STATE OF MAINE  
DEPARTMENT OF TRANSPORTATION  
16 STATE HOUSE STATION  
AUGUSTA, MAINE 04333-0016

February 2, 2023  
Subject: Acadia Gateway  
State WIN: 017163.03  
Location: **Trenton**  
**Amendment No. 7**

Make the following changes to the bid documents:

1 MEZZANINE FINISH FLOOR PLAN  
1/8"=1'-0"

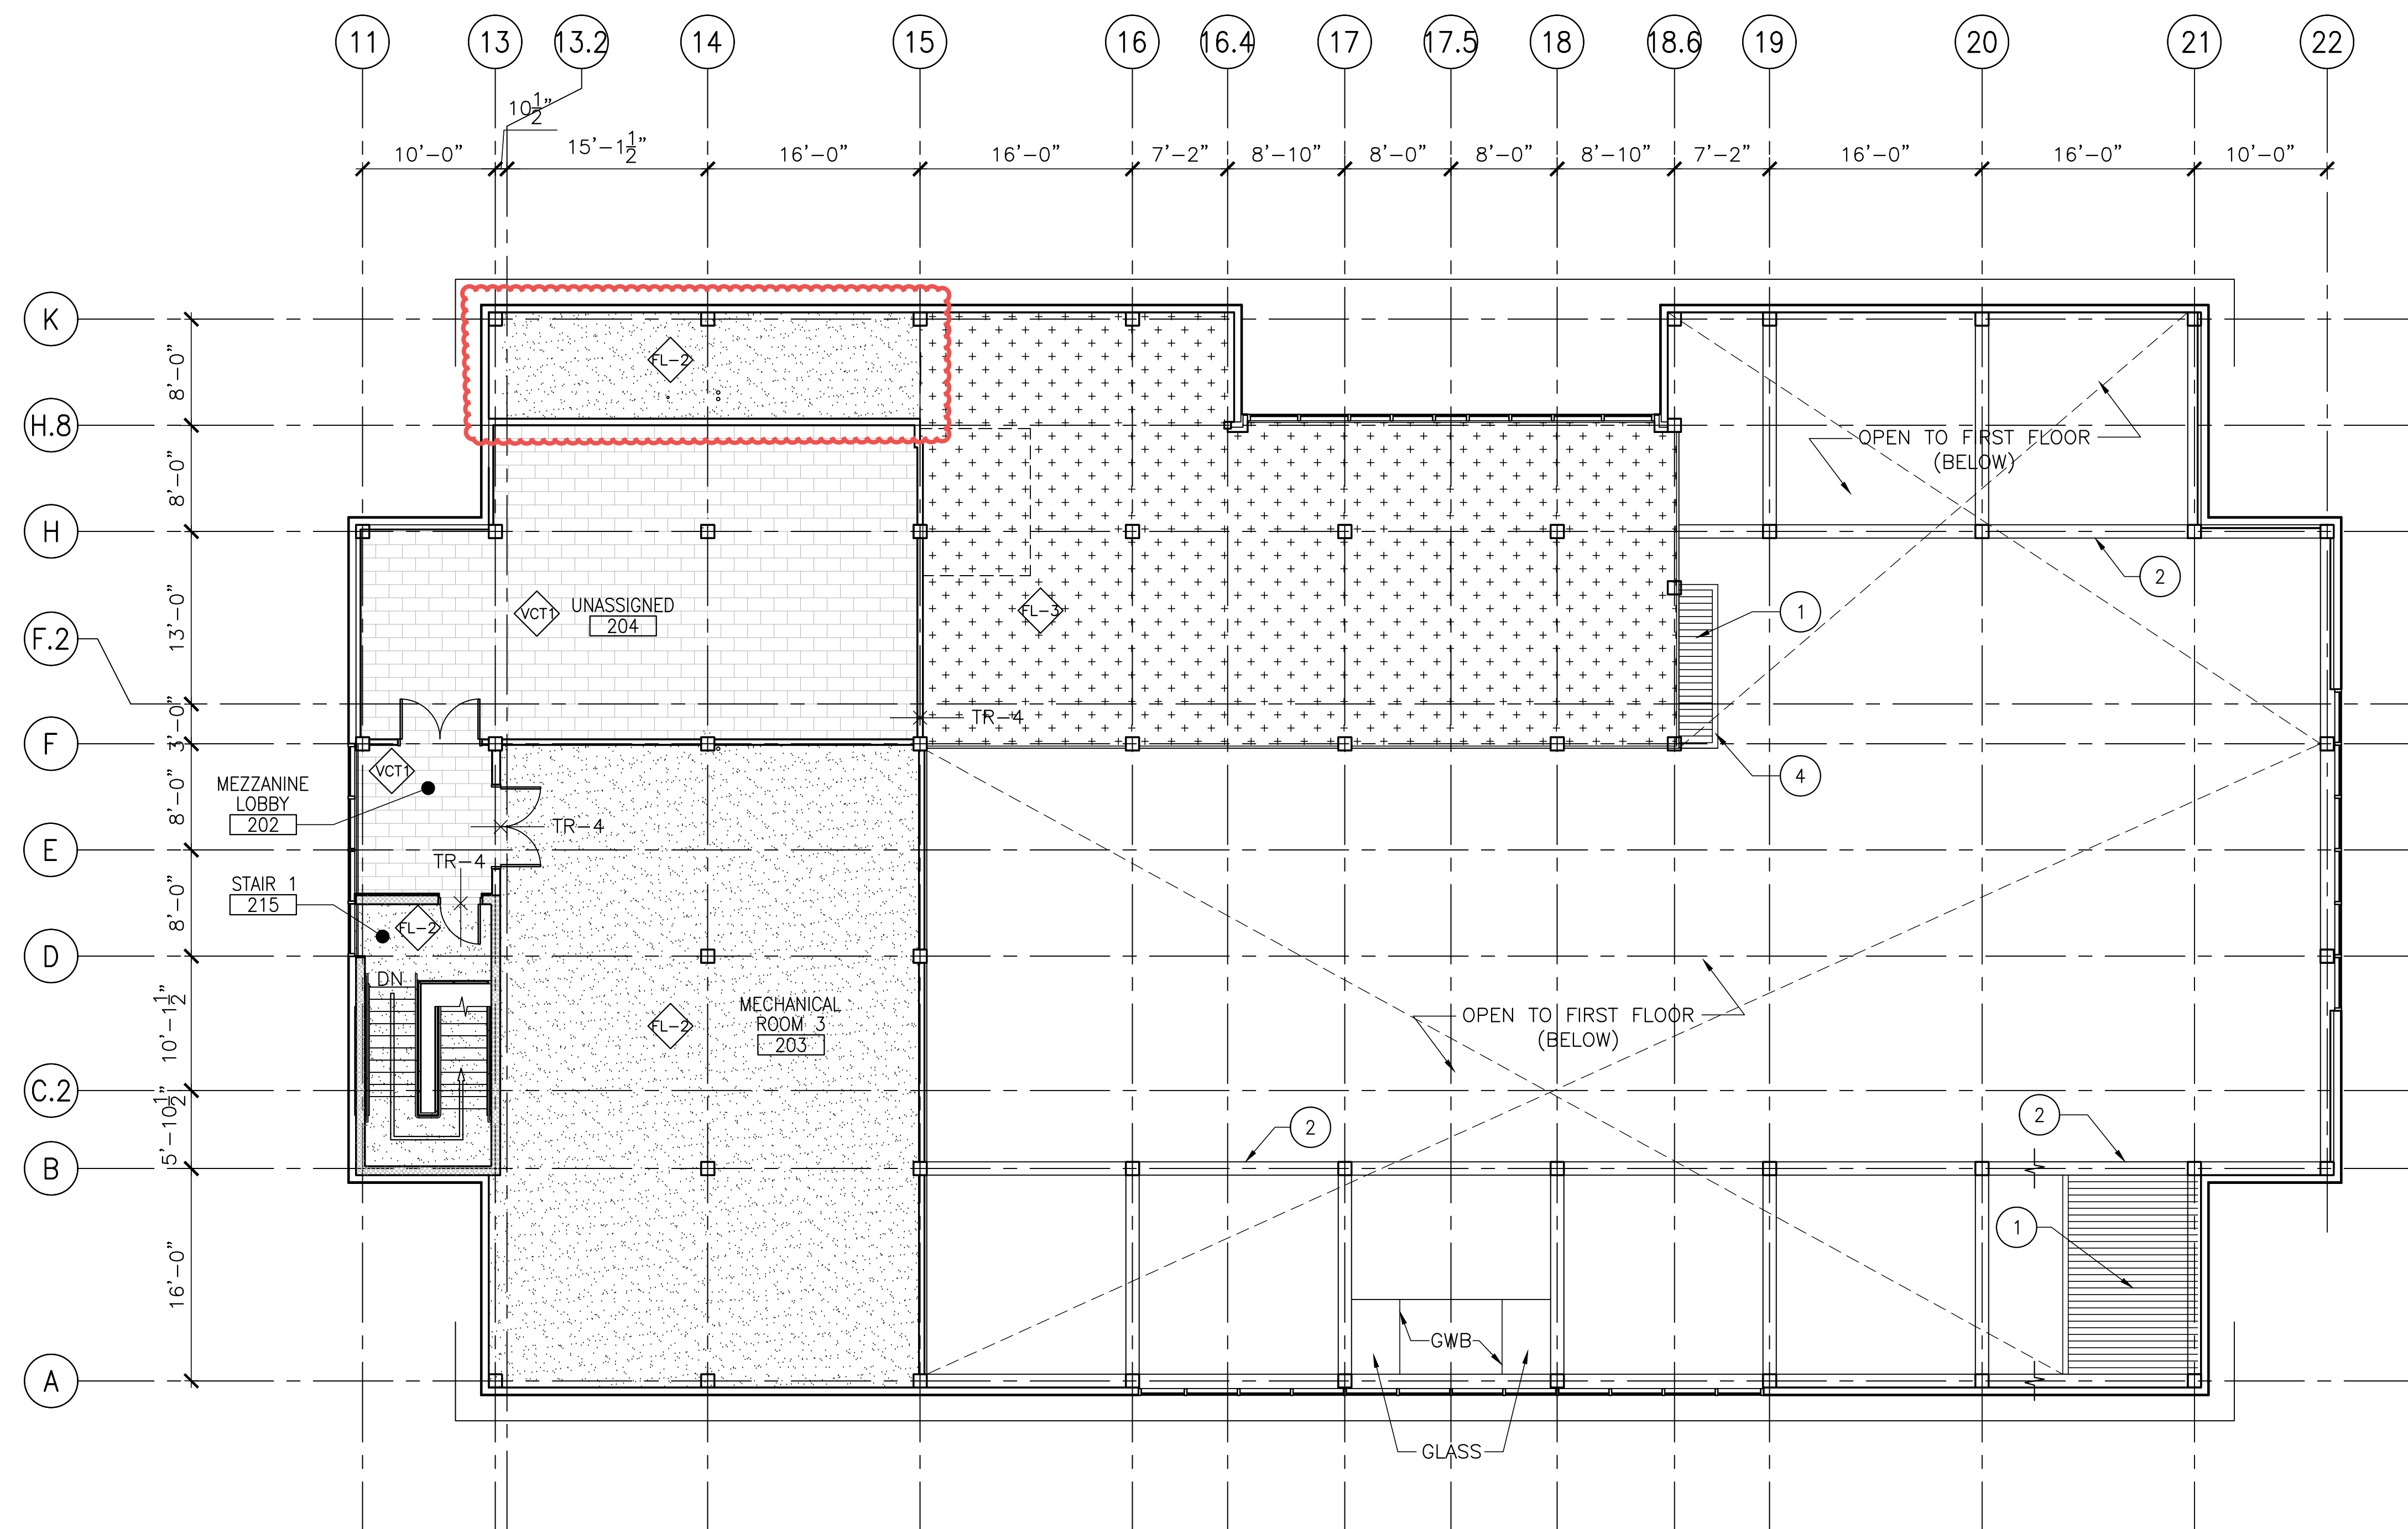
**Question:** The bottom Q&R on page 12 of 102 for Addendum 05 states that the area between 15-18.6, F-k shall be exposed, fire-treated plywood, as per the Structural Drawings, and also that Finish Plan A613 has been updated to reflect this change. Updated plan sheet A613 indicates Flooring FL-3 for H.8-K 13-15. This Flooring would mean that there is no 2" Topping Concrete in this area, which is in conflict with what is shown on SF101. Please confirm whether the area H.8-K, 13-15 receives a 2" Topping Concrete. If so, please confirm the correct Floor Finish for this area.

**Response:** The area H.8-K, 13-15 should receive a 2" Topping Concrete, per the structural drawing SF101. A613 has been updated in Amendment 7 to reflect this.
